CITY OF SEASIDE
BOARD OF ARCHITECTURAL REVIEW

MEETING
COUNCIL CHAMBER
440 Harcourt Avenue
Wednesday, September 16, 2015
5:30 PM

Item No.: 5.A.

SUBJECT: Architectural Review Application No. BAR-14-32. Bahman Ben Ahmadi, property owner and applicant, requests design review approval to construct a second story addition onto the existing Rod and Ros service station located at 1898 Fremont Boulevard in the Commercial Mixed Use (CMX) Zoning District. This project is exempt from the California Environmental Quality Act pursuant to Class 1, Section 15301.e.1: Existing Facilities. (Continued from April 1, 2015)

Sheet Title:
SITE PLAN

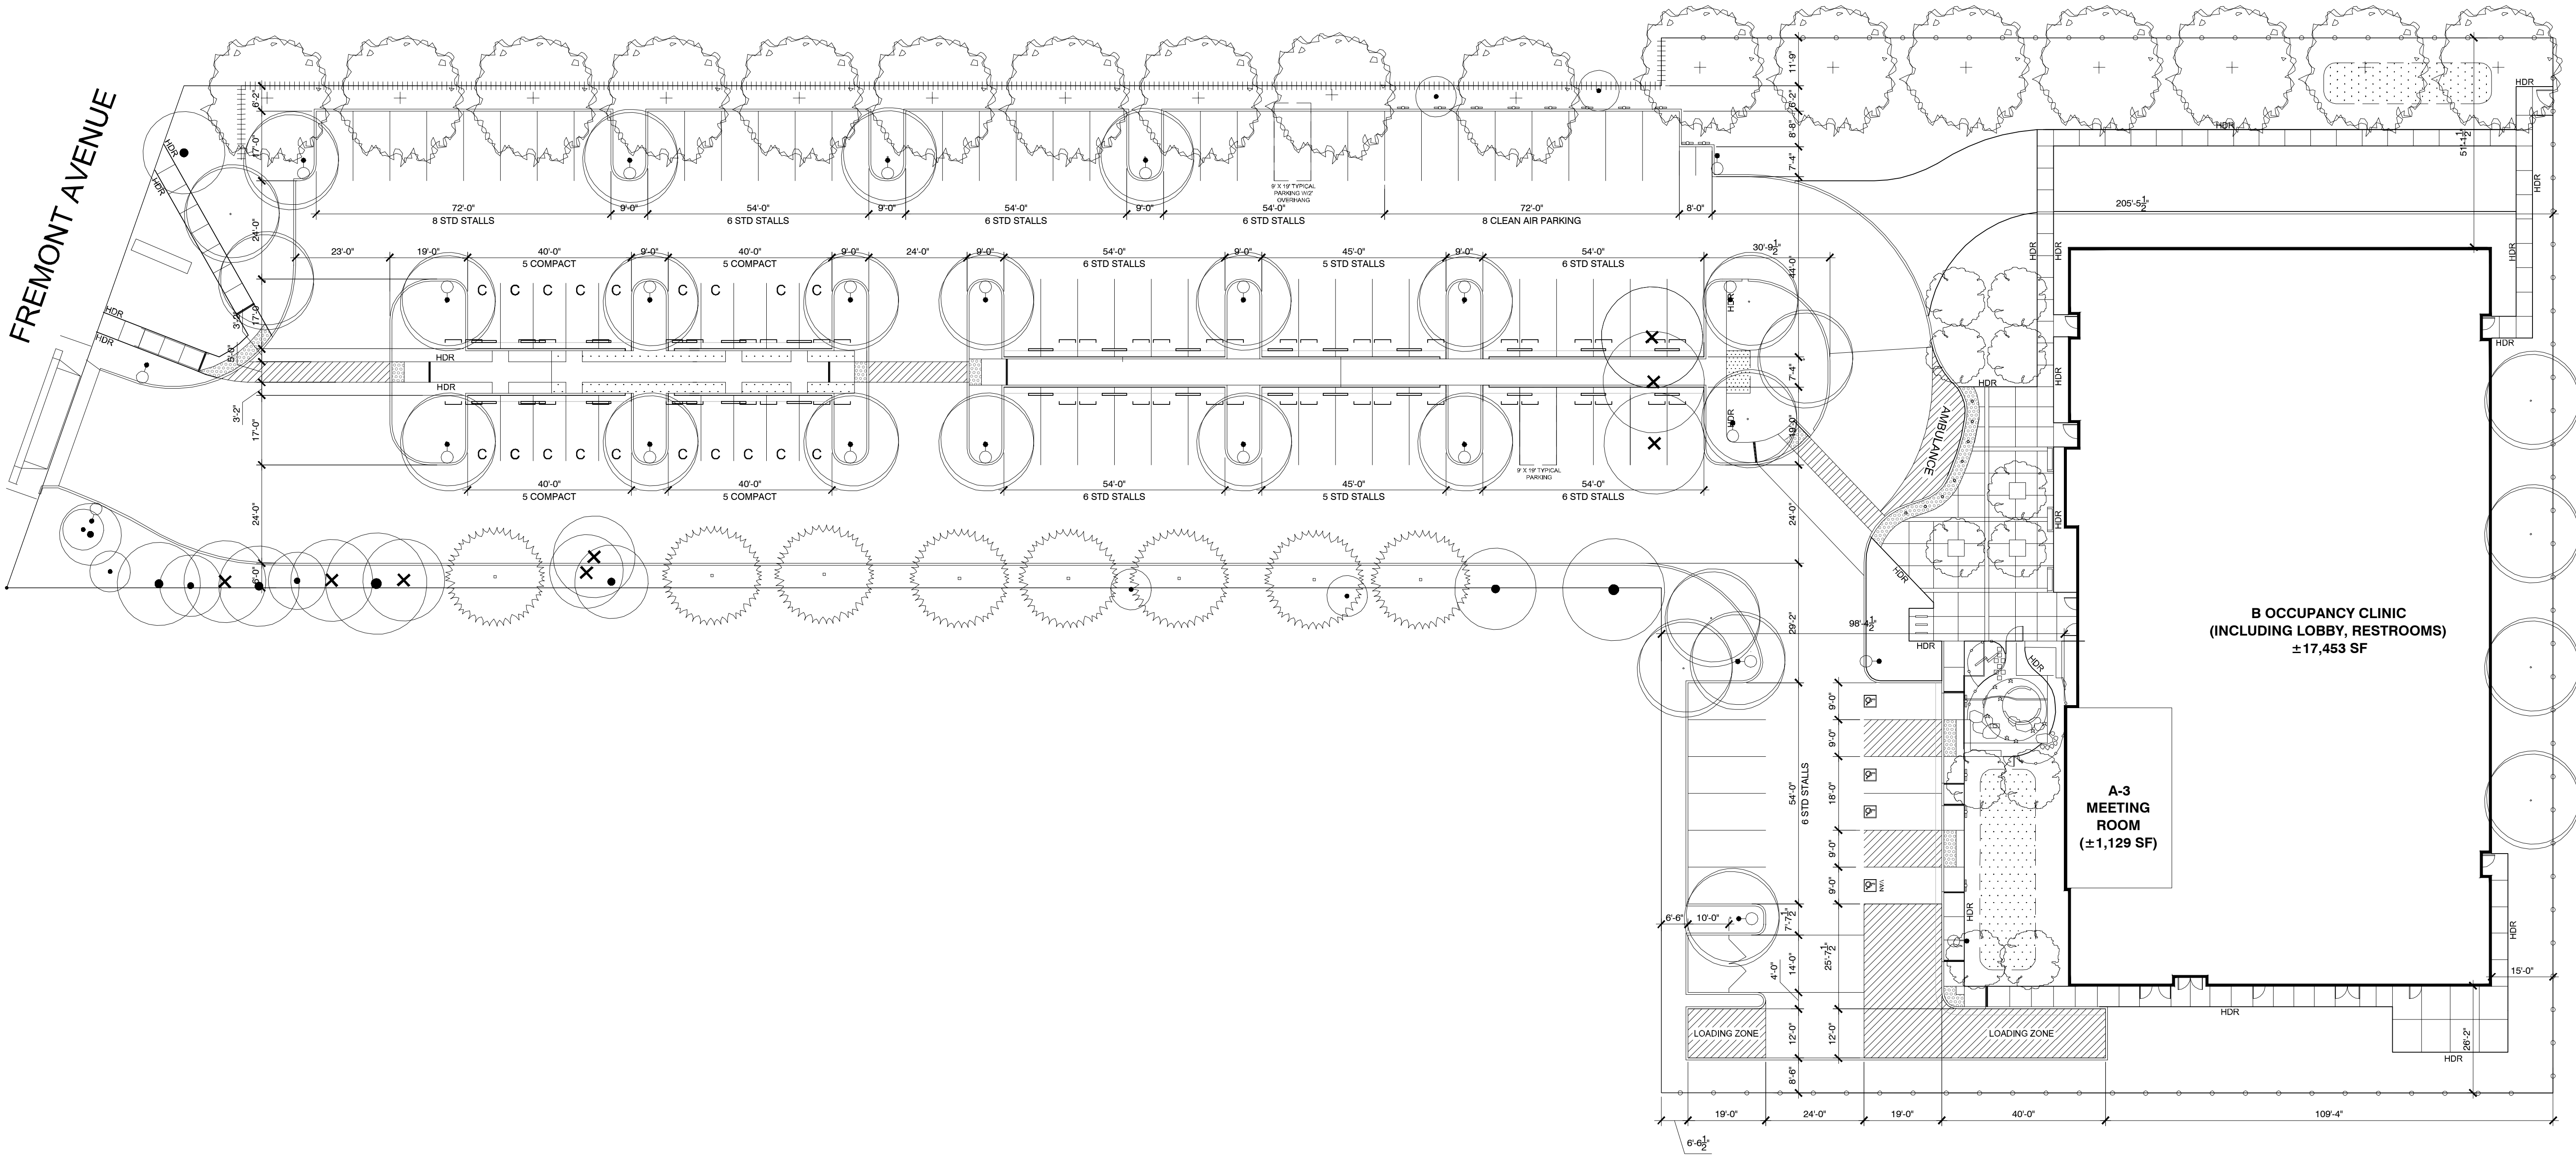
- Width of perimeter landscaping strips adjacent to side or rear property lines. The perimeter landscape strips have been reduced from the required eight feet to four and six feet in some locations. The Board should discuss the type of planting within these landscape strips to determine the adequacy of the plant materials and how the landscape strips function in relation to providing the required landscape coverage.

- *Concentration of a majority of the parking at the front of the lot* – “When previously developing a design alternative to renovate the existing building, two important considerations became evident. The necessary staged construction approach would not allow the County to provide the continuous level of service required during construction by federal government and because of the sub-optimal configuration of the existing building, its remodeling would not allow enhancement of the existing level of medical care and services as desired. It became evident that financial investment in a new facility that can offer state-of-the-art services in a functional and efficient layout was the more prudent course of action. Prior to proceeding with this new site plan, the County met with the City Staff to review this direction in December 2014 and it was agreed that we could proceed.”

- *Concentration of a majority of the parking at the front of the lot* – When previously developing a design alternative to renovate the existing building, two important considerations became evident. The necessary staged construction approach would not allow the County to provide the continuous level of service required during construction by federal government and because of the sub-optimal configuration of the existing building, its remodeling would not allow enhancement of the existing level of medical care and services as desired. It became evident that financial investment in a new facility that can offer state-of-the-art services in a functional and efficient layout was the more prudent course of action. Prior to proceeding with this new site plan, the County met with the City Manager and Staff to review this direction in December 2014 and it was agreed that we could proceed.
